**REZONING, PUD &
SUBDIVISION STAFF REPORT**

DEVELOPMENT NAME Quality Valve

LOCATION 2948 and 2950 Mathers Street
(Northwest corner of Mathers Street and LeFevre Street)

REQUEST Rezoning from B-1 to B-3, Planned Unit Development, Subdivision

SITE PLAN

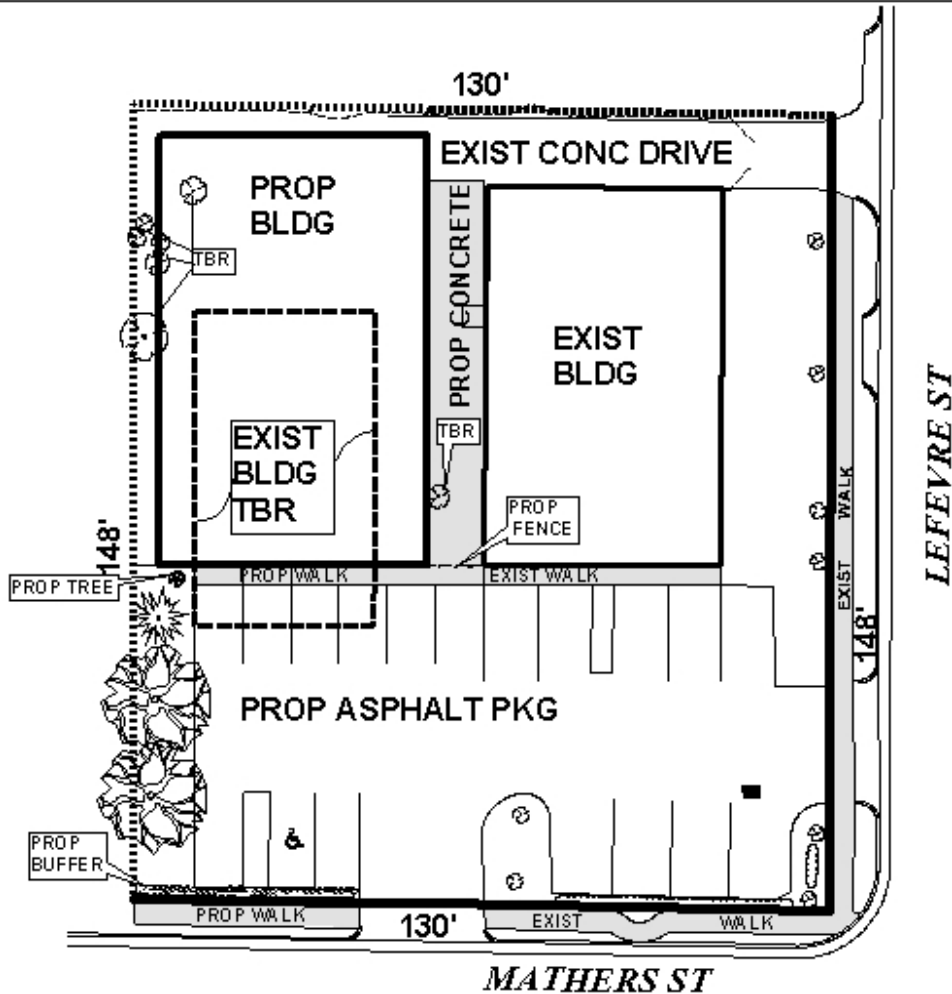
ENGINEERING COMMENTS Applicant should provide professionally licensed survey determining stormwater detention available for existing and proposed impervious area. Existing unused driveway apron should be removed and the rights of way should be properly rehabilitated. Must comply with all stormwater and flood control ordinances. Any work performed in the right of way will require a right of way permit.

TRAFFIC ENGINEERING COMMENTS Driveway number, sizes, location and design to be approved by Traffic Engineering and conform to AASHTO standards.

Property to be brought into full compliance with landscape and tree requirements of the zoning ordinance. Property to be developed in compliance with state and local laws that pertain to tree preservation and protection on both city and private properties (City Code Chapters 57 and 64 and State Act 61-929).
